Preliminary responses to OEH and SEWPaC comments on the Preferred Project
Report and Response to Submissions — biodiversity (26 March 2013)

Re: Cobbora Coal Project – Preliminary Responses to OEH and SEWPaC Comments on the Preferred Project Report and Response to Submissions – Biodiversity

DATE: 19/3/2013
MEMO TO: Department of Planning and Infrastructure – Stephen O’Donoghue
FROM: Gavin Heydon
SUBJECT: CLARIFICATION OF TAILINGS INFORMATION
REFERENCE:

The purpose of this addendum is to correct the results presented in Appendix E that were affected by a water balance model error, and to discuss the wider implications of the error for the Surface Water Assessment and Environmental Assessment. In addition, further information is provided in the addendum on additional model sensitivity analyses undertaken to address a concern of the DP&I's reviewer regarding the reliance of the mine on the surface water entitlement from the Cudgong river source. Specifically, the reviewer raised the concern that the volume of groundwater inflow to the mine pits available for use in the mine water management system may have been overestimated.

Figure A2.1 – Water balance for SD9 for mine stage year 4 and 90th percentile rainfall (wet) year of 1990 (plot 1 of 3)

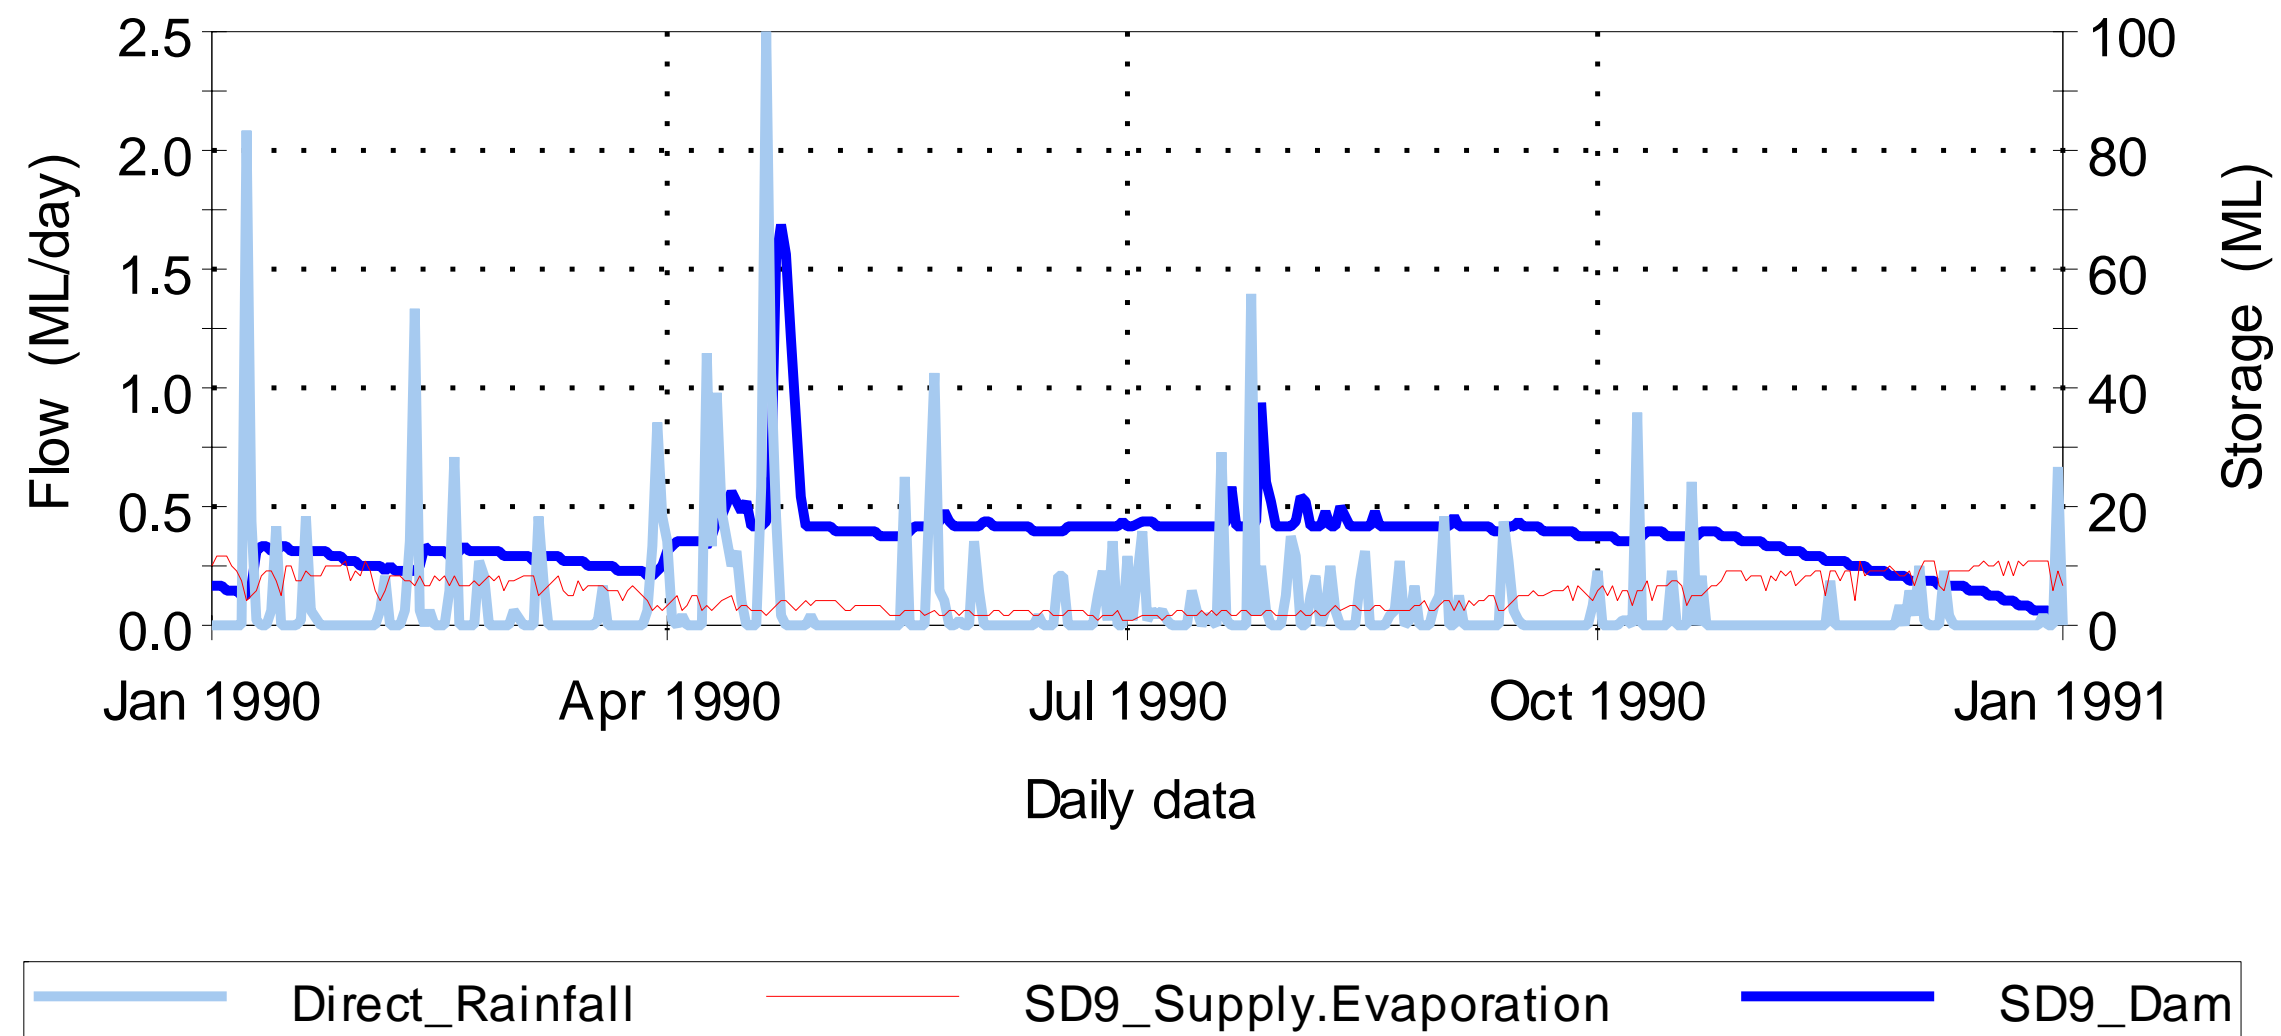
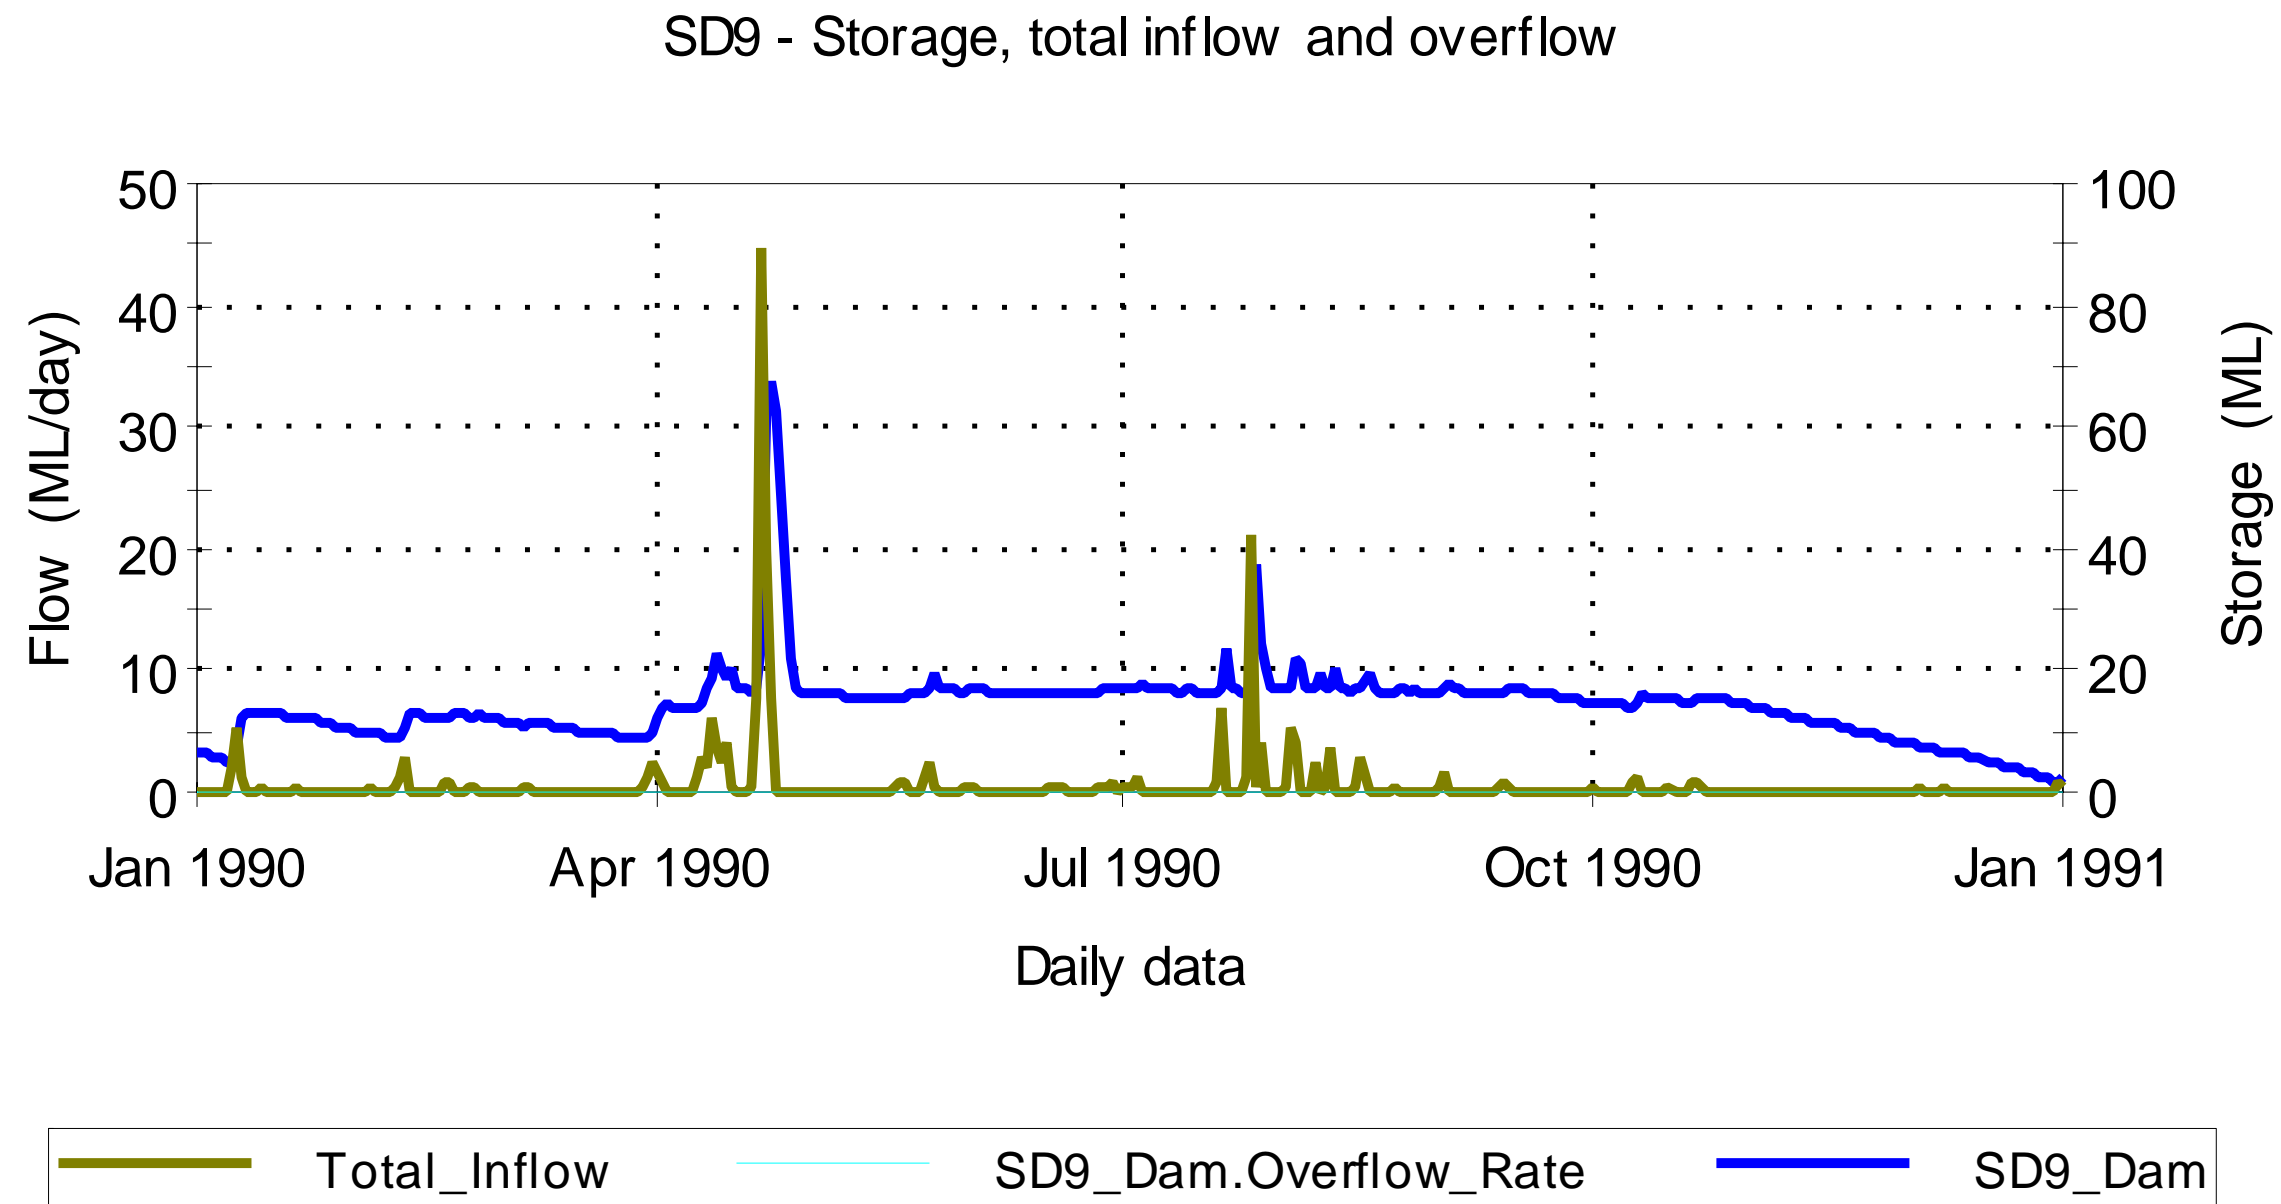
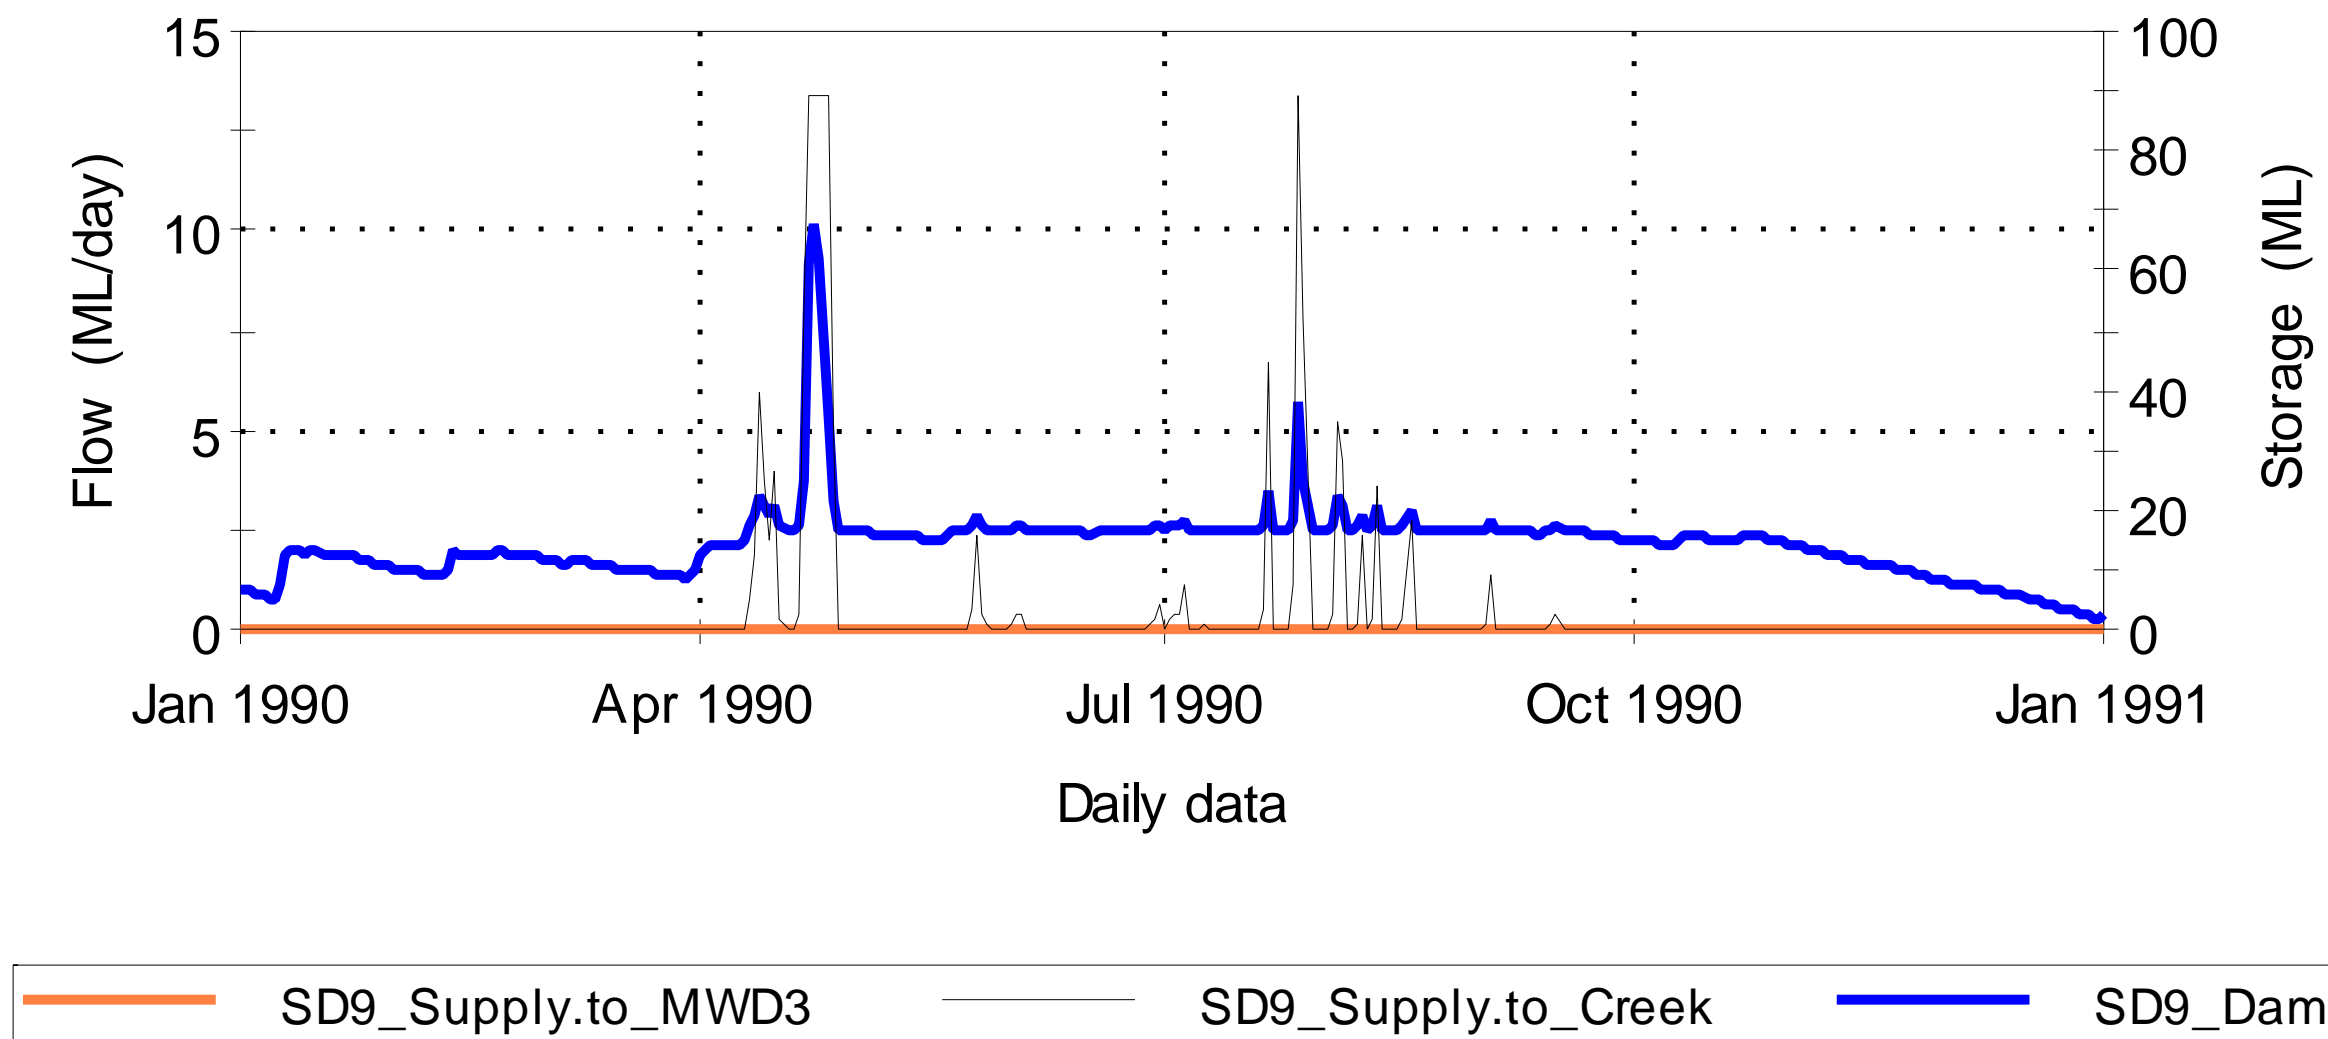
Figures A2.1 to A2.3 show the daily simulation for SD9 for 1990 (wet) conditions. During the simulation, numerous outflows to the creek occur but no pumping to MWD3 occurs as the MWD3 storage volume was more than 25% full (i.e. above the operating rule for SD pumping to MWDs). The storage in this dam did not exceed the maximum water holding capacity hence no overflow occurred. Evaporation gradually made the dam dry towards the end of 1990.
